ADDENDUM 002

DATE: July 23, 2025
COMM NO: 24058.001
PROJECT: VINTON War Memorial Renovation

TO: All Bidders
FROM: Shawn Emmons
RE: Addendum No. 2

A2-3

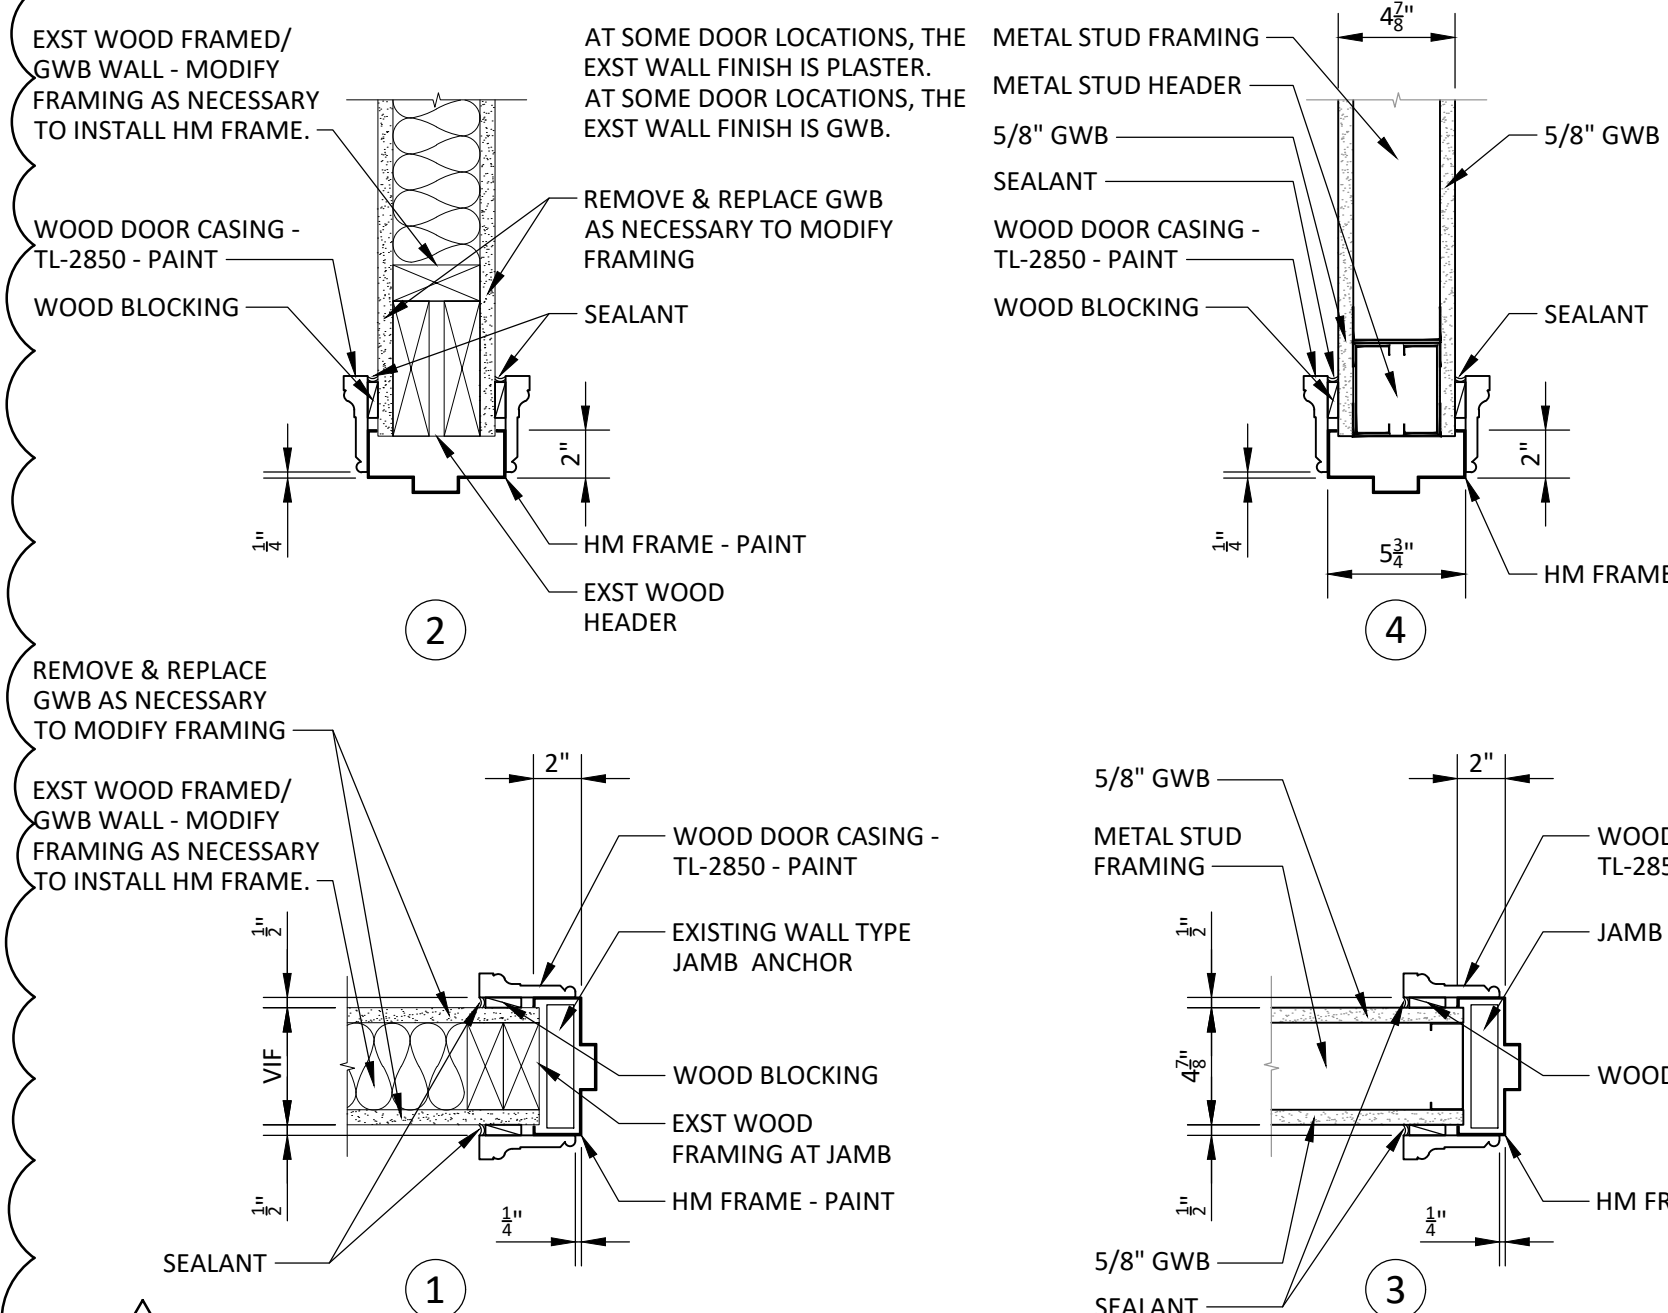
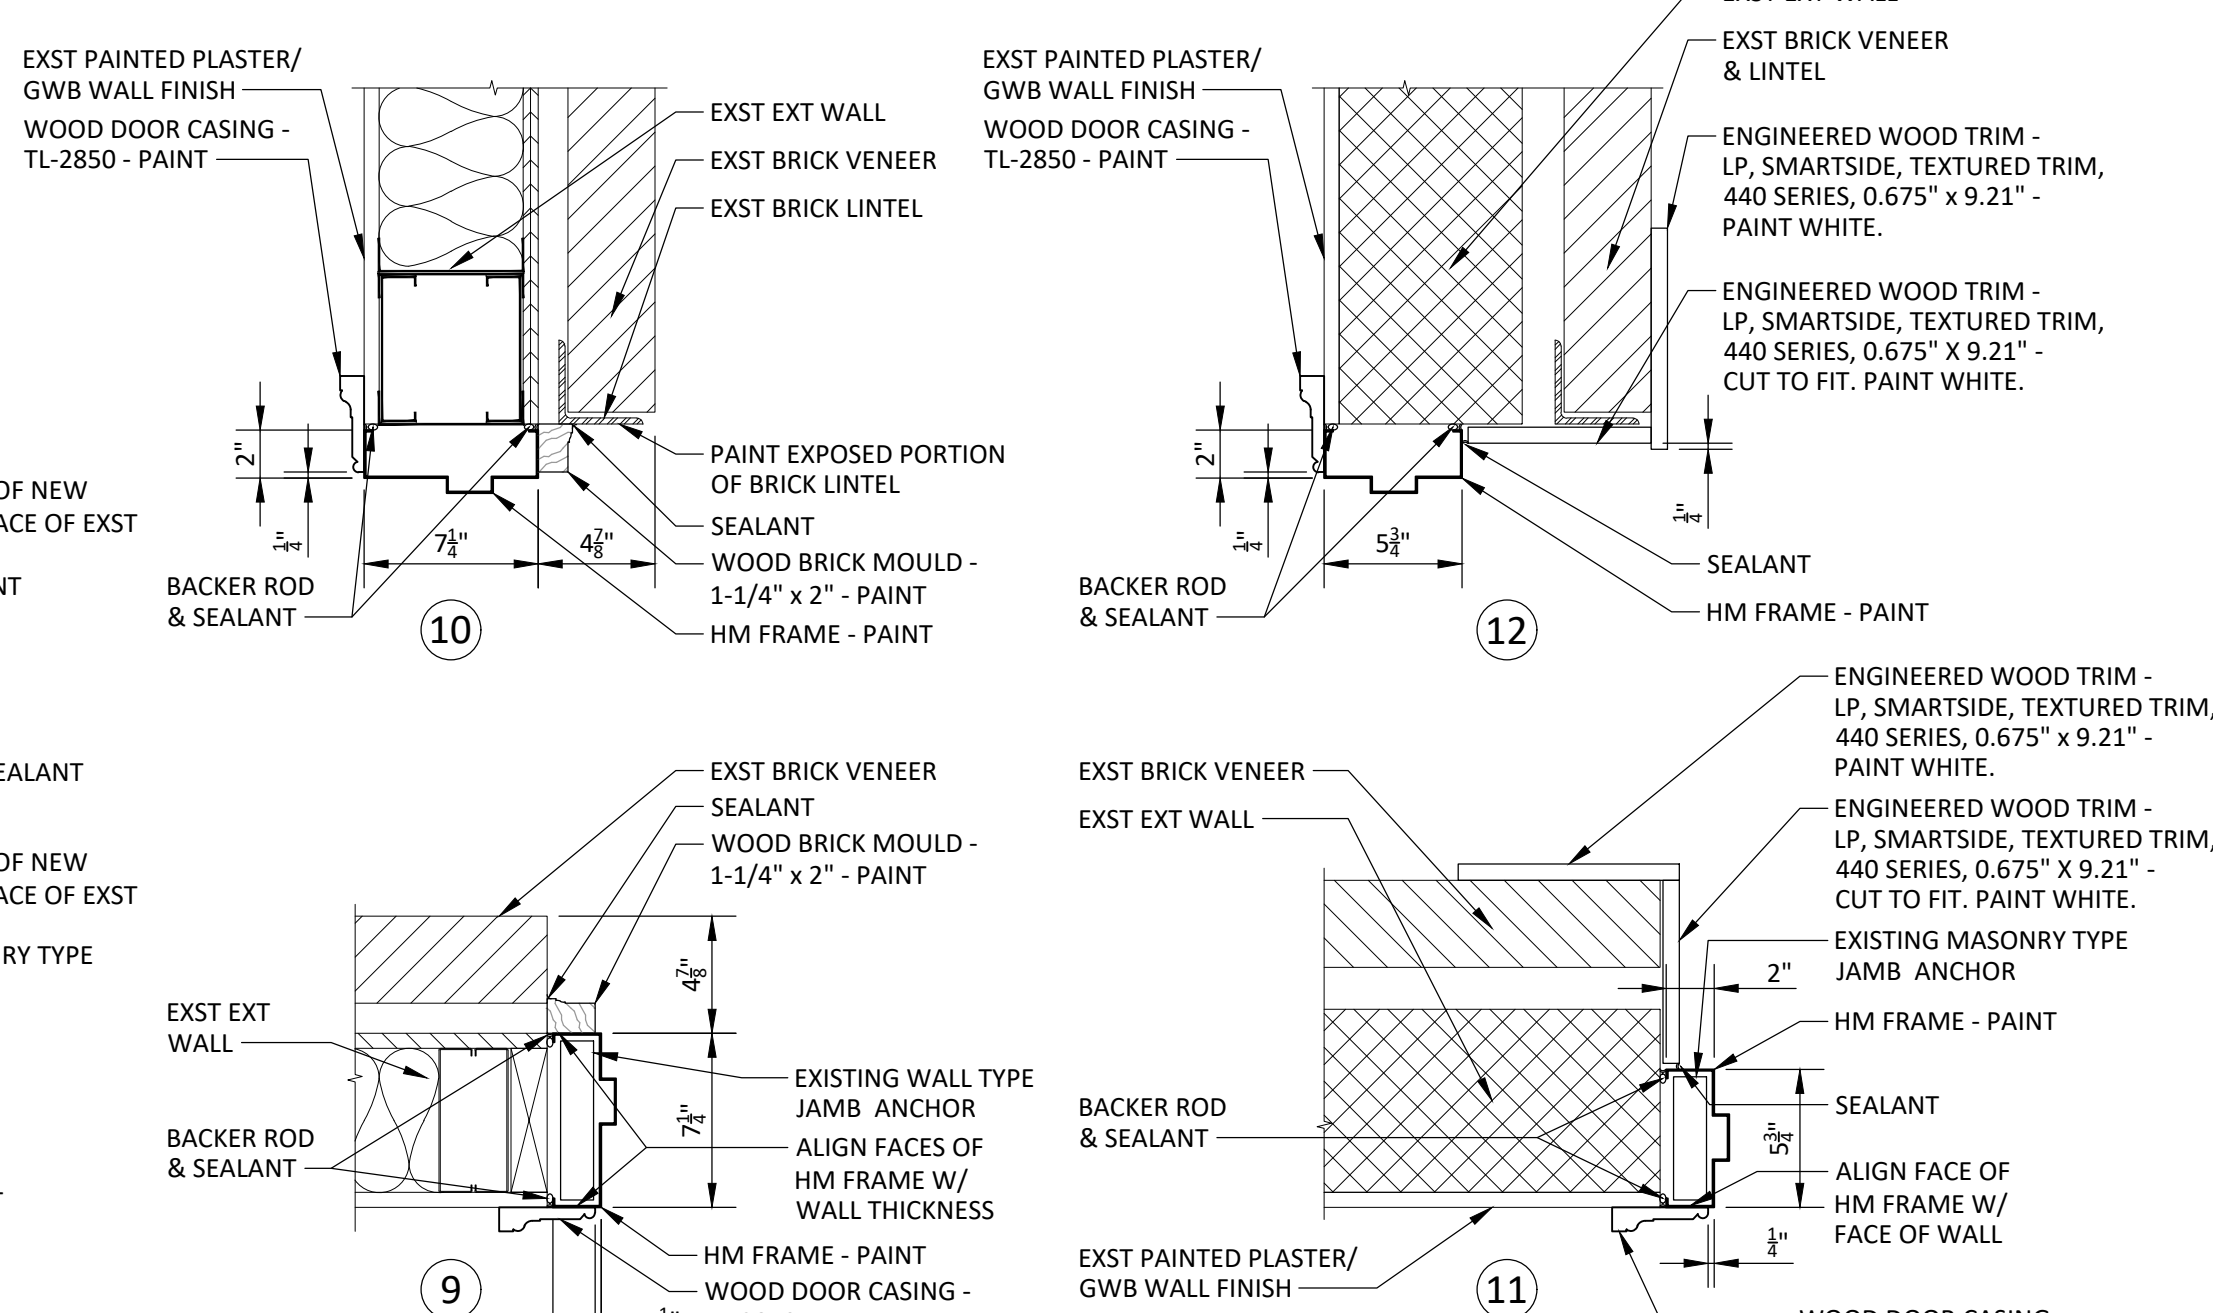
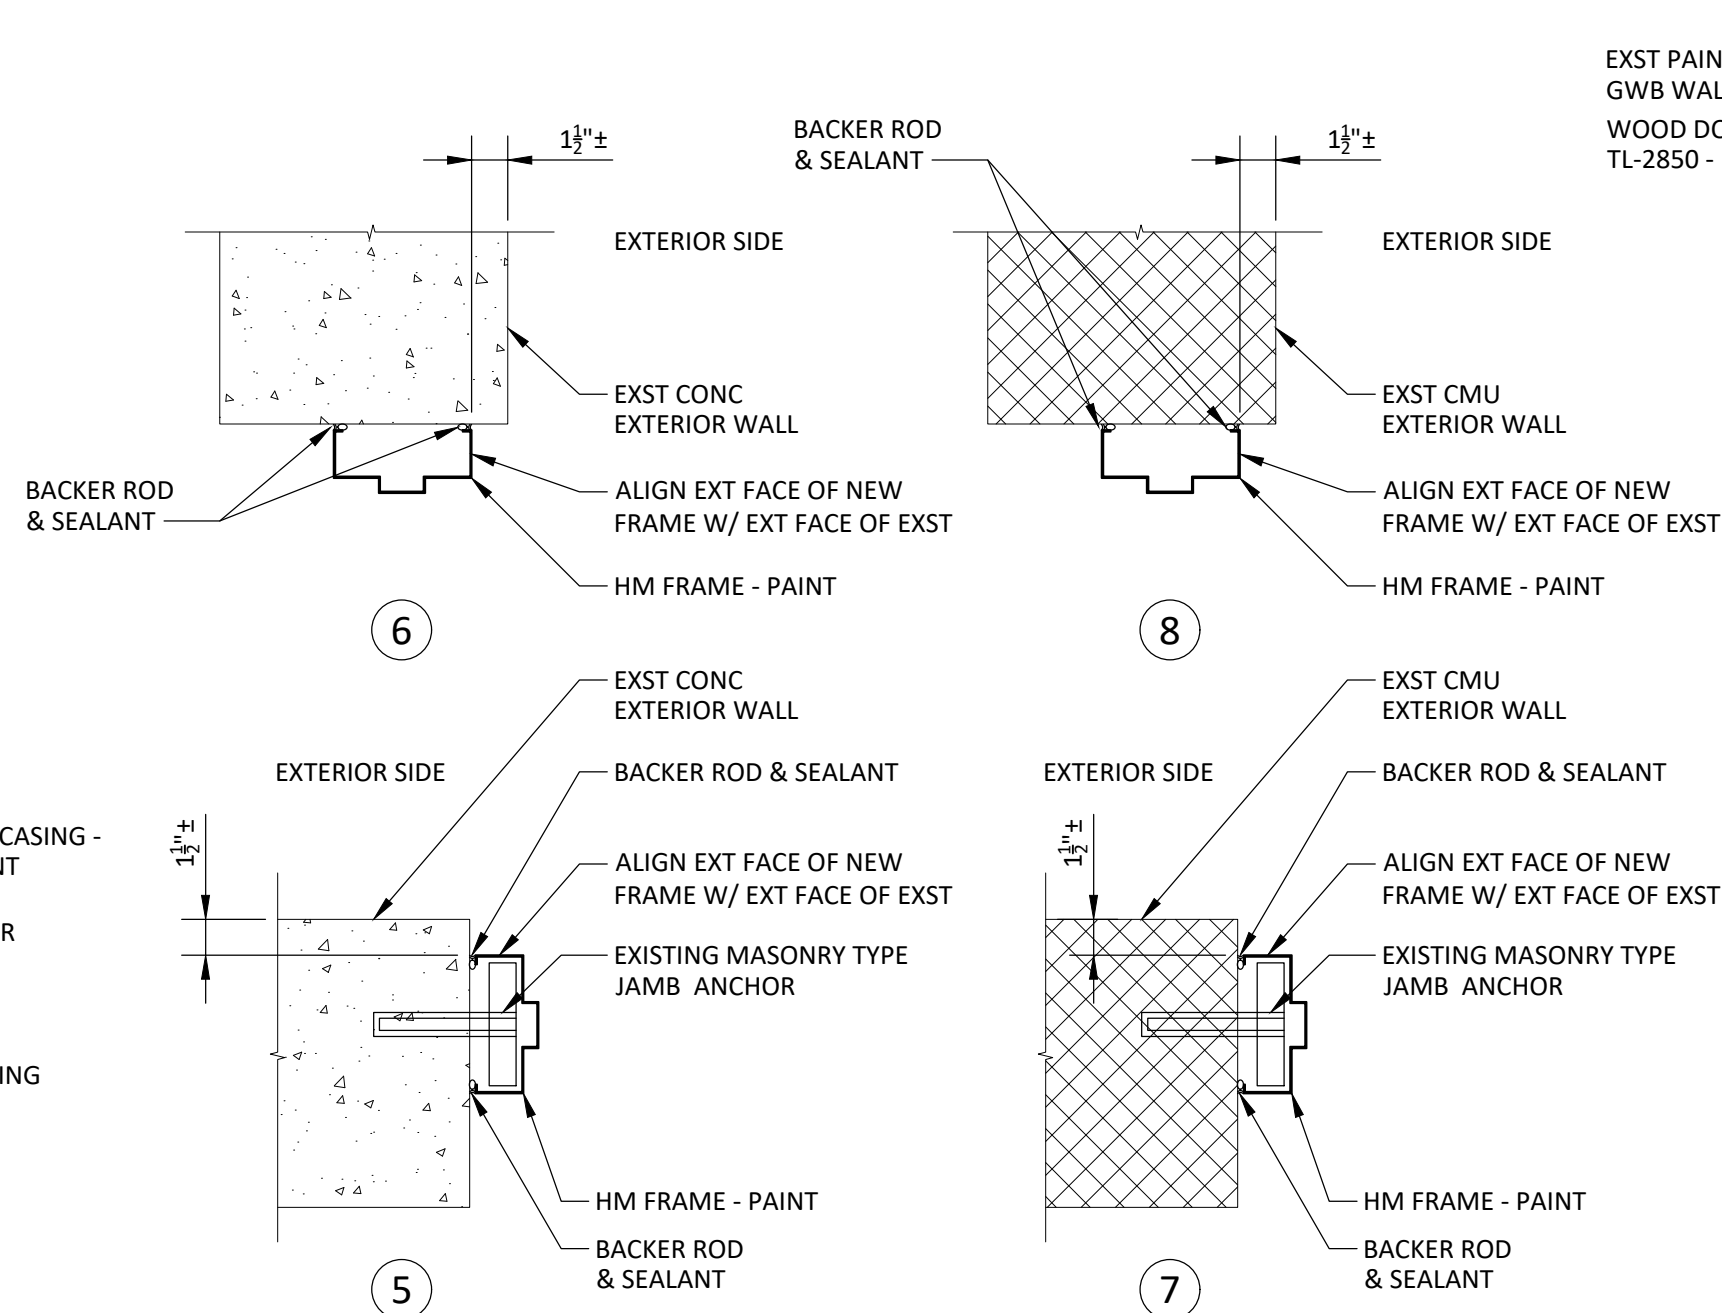
REPLACE sheet dated JUNE 20, 2025 with Sheet A2-3 identified with Delta 2, ADD NO 2, dated 7/23/25.
See added Roof Dormer Elevations A2-3.3.
See added Door Details A2-3.4.

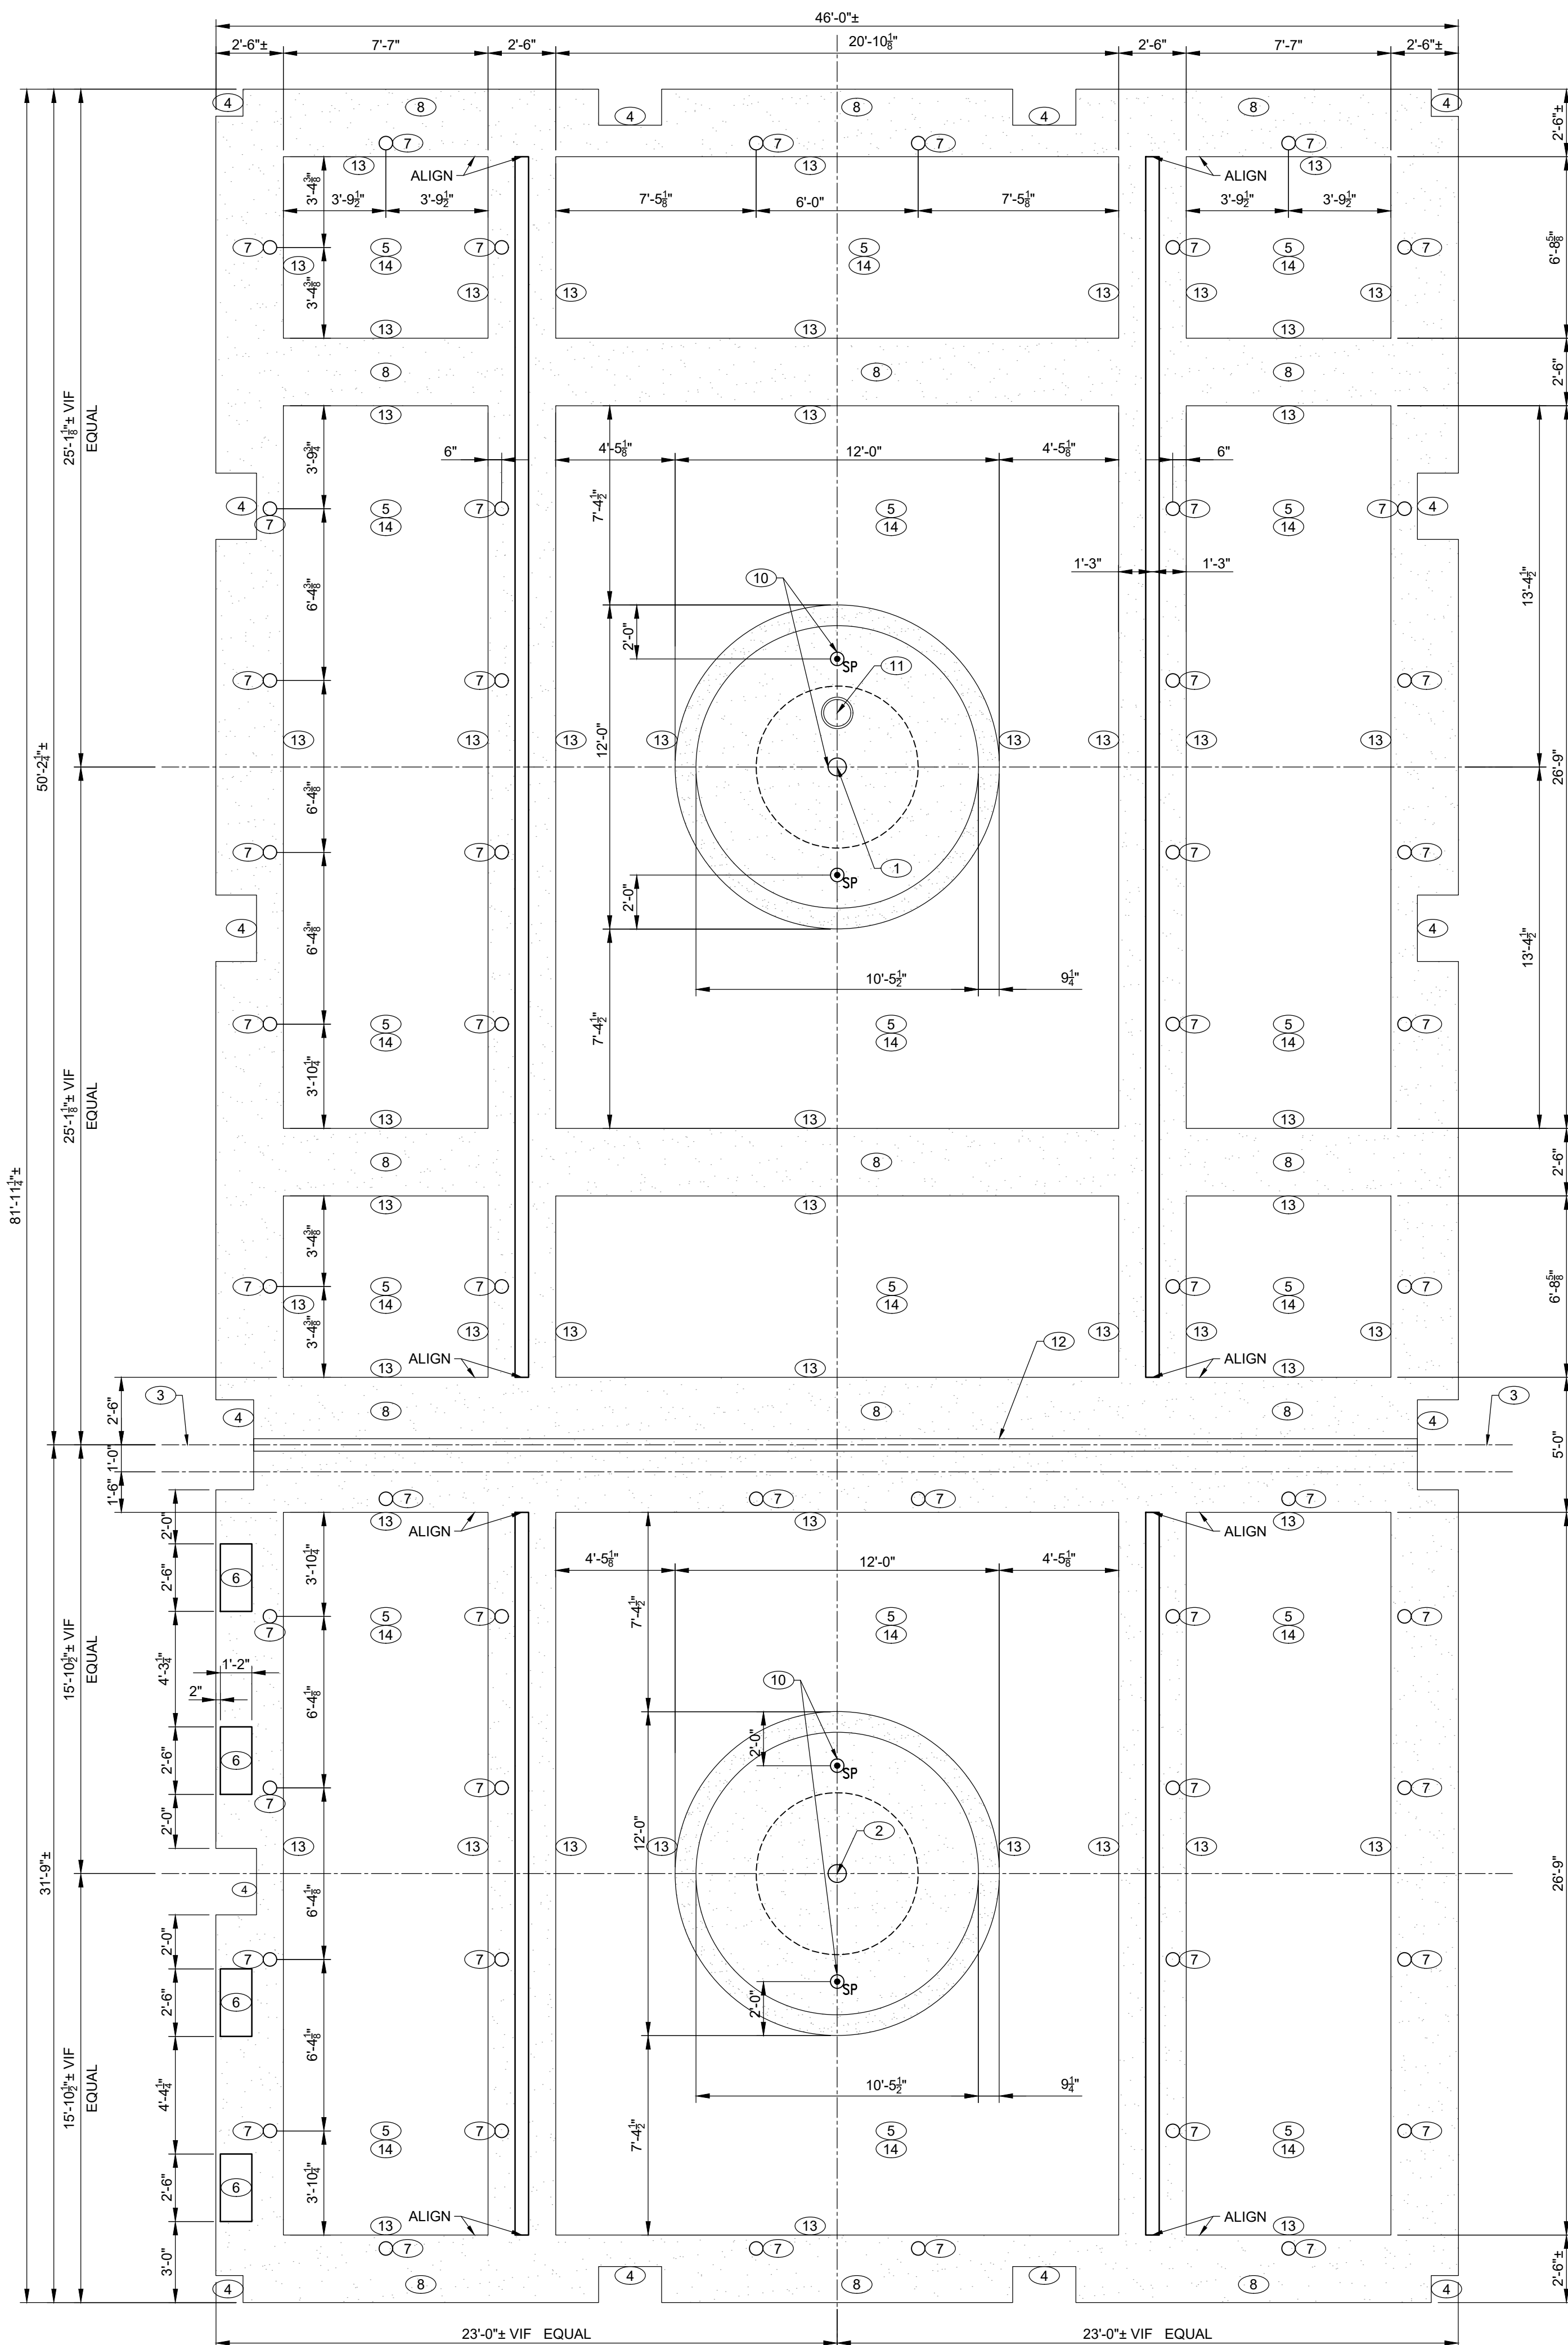
REPLACE sheet dated JUNE 20, 2025 with Sheet A7-3 identified with Delta 2, ADD NO 2, dated 7/23/25.
Plan Note 13 added to indicate painting of full height of bulkhead faces above ceiling panels.
Plan Note 14 added to emphasize extent of sheet lighting installation of Light Fixture Types J1, J2, J3, & J4 above acoustical panels.

- 11 RELOCATED SPEAKER.
- 12 OPERABLE PARTITION TRACK.
- 13 PAINT FULL HEIGHT OF ALL FACES OF BULKHEADS FROM BOTTOM OF BULKHEAD TO NEW GWB. INSTALLED AT THE BOTTOM OF EXST ROOF FRAMING AT APPROX 15'-4" AFF. PAINT WHITE TO ENHANCE BRIGHTNESS OF LIGHT FIXTURES INSTALLED AT 15'-4" AFF ABOVE THE ACOUSTIC PANELS.

- 14 INSTALL SHEET TYPE LED LIGHT FIXTURE AT GWB AT BOTTOM OF EXST ROOF FRAMING AT APPROX 15'-4" AFF. FIXTURE SHALL BE INSTALLED FROM FACE OF BULKHEAD TO FACE OF BULKHEAD BOTH DIRECTIONS AT ALL ZONES OF THE CEILING COINCIDENT WITH WHERE ACOUSTIC PANELS ARE SHOWN TO BE INSTALLED. SEE FIXTURE TYPES J1, J2, J3, & J4 SHOWN ON SHEETS E1-1 & E4-1. SEE SHADED REGION ON SHEET E1-1 FOR INDICATION OF THE EXTENT OF THIS FIXTURE TYPE.
